ADDENDUM 1

Project: Jorstad Feeders Civil Construction

Date: 5/12/2022

Changes and clarifications to the Bid Documents and Plan-Set for the above-referenced project are as follows:

DWN. BY: CQ	PROJECT: JORSTAD SUBSTATION URD FEEDERS
CRD. BY: EAN	LOCATION: MASON COUNTY
APPD. BY: WFW	CLIENT: MASON COUNTY PUD NO. 1 SHELTON, WA
DATE: 02/24/2026	TITLE: UR2-2 TRENCHING GUIDES
	SHEET NO. JSF.D04.03

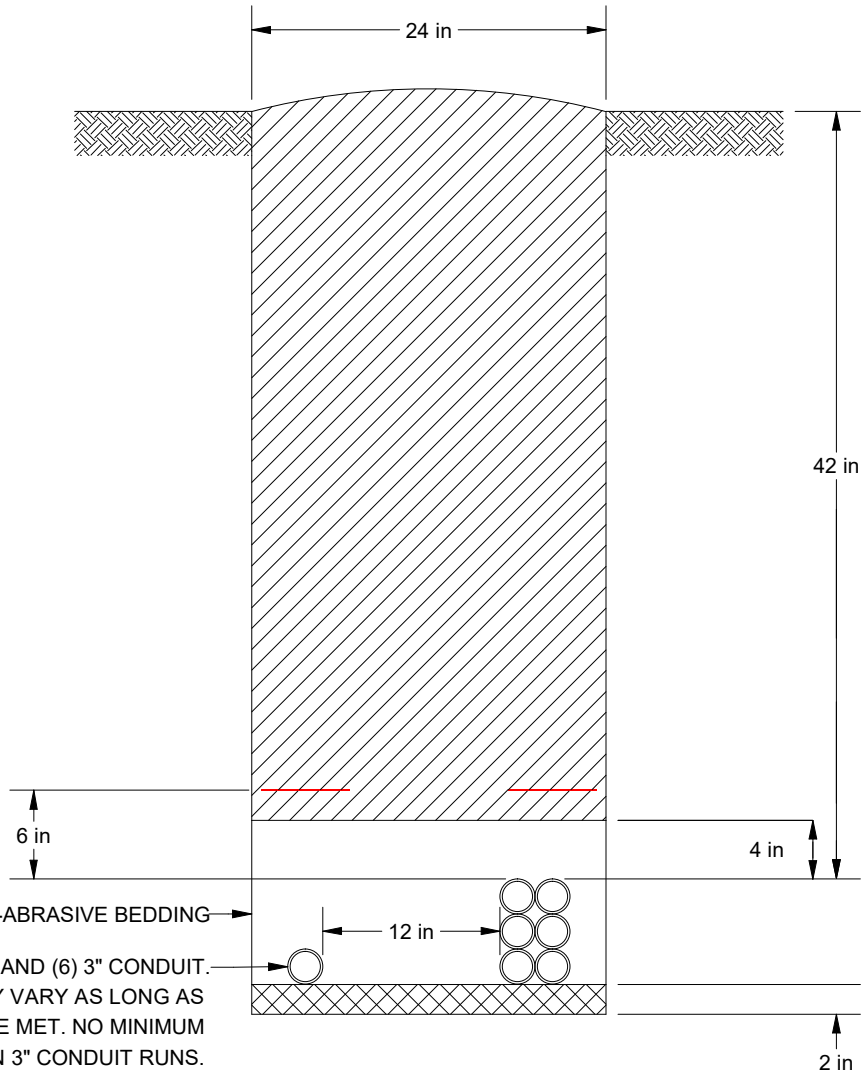
1. This is a federally funded project. Review the appendices of the bid binder for more information.
2. JSF.D04.03 Trenching Guidelines/Specifications

- a. This should show (1) 2" and (6) 3" conduits
3. PUD Furnished materials per JSF.D09.01
 - a. 3" & 2" Stick Conduit
 - b. Vaults
 - c. Joints/Sweeps
 - d. Warning tape

INSTALL (1) 2" CONDUIT AND (6) 3" CONDUIT.
 CONDUCTOR LAYOUT MAY VARY AS LONG AS
 CLEARANCE REQUIREMENTS ARE MET. NO MINIMUM
 SPACING REQUIRED BETWEEN 3" CONDUIT RUNS.
